QUALITY ASSURANCE MONTHLY SITE ASSESSMENT REPORT

Airfield Modernization Program Runway 5L-23R Reconstruction Project 2 / Project 3

05/14/20 05/27/20

AIRFIELD MODERNIZATION PROGRAM RUNWAY 5L-23R RECONSTRUCTION

Photo 60 Sta. 341+86 RT (RW 5L-23R) Project 4

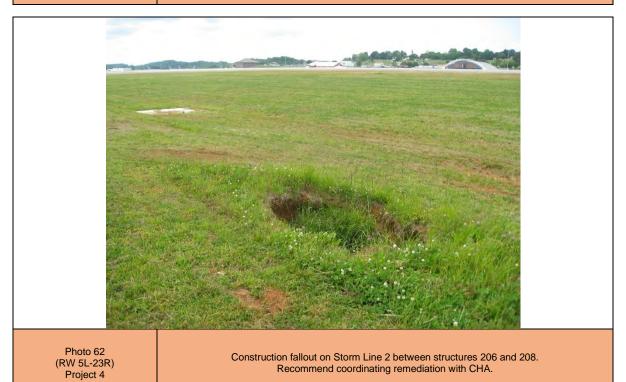
Construction fallout on Storm Line 2 between structures 204 and 206. Recommend coordinating remediation with CHA.
